#503-22

PUBLIC HEARING MEMORANDUM

SUBJECT: **Petition #503-22** for SPECIAL PERMIT/ SITE PLAN APPROVAL to raze the existing single-family dwelling and construct five single-family attached dwellings, dimensional waivers for driveway and parking location, and to allow a retaining wall greater than four feet in height within a setback at **24 Wilson Cir**, Newton, Ward 6, on land known as Section 54 Block 22 Lot 19, containing approximately 28,513 sq. ft. of land in a district zoned MULTI RESIDENCE. Ref: 7.3.3, 7.4, 3.4.1, 6.2.3.B.2, 5.4.2.B of Chapter 30 of the City of Newton Rev Zoning Ord, 2017.

24 Wilson Circle

Proposed front and rear elevations

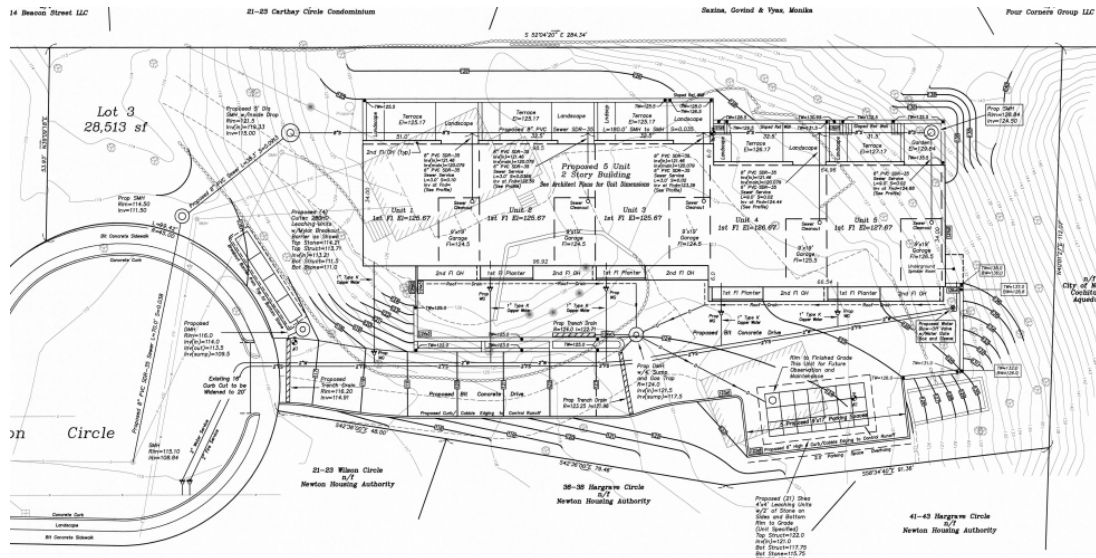
The petitioner is proposing to create five attached single-family dwellings in a two story structure measuring 25.35 feet in height, less than the maximum 2 ½ stories and 36 feet allowable by special permit.
